February 16th, 2024

MCQV3 / MCQI3-Ø63(S) Profile Change Notification

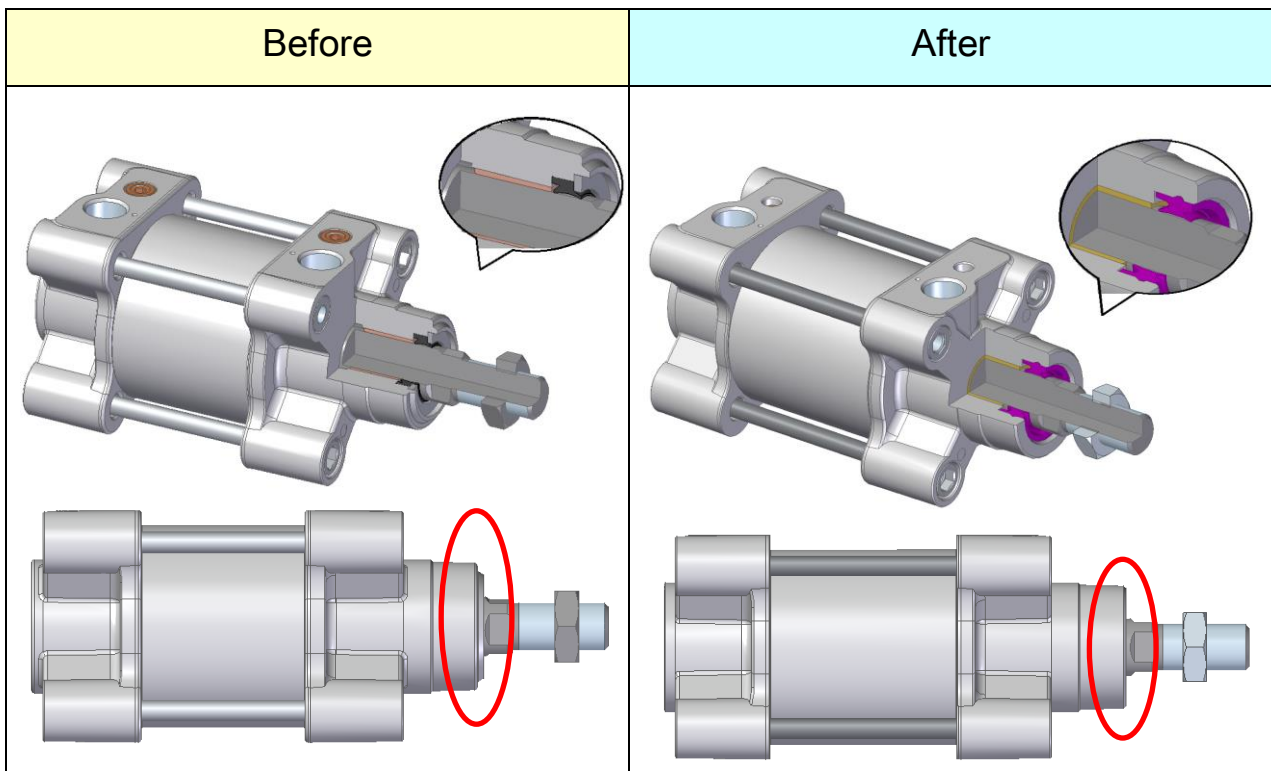
1. Model series
MCQV3 / MCQI3-Ø63(S)
2. Design change reason
Change profile and merge parts for better stability.
3. Change descriptions
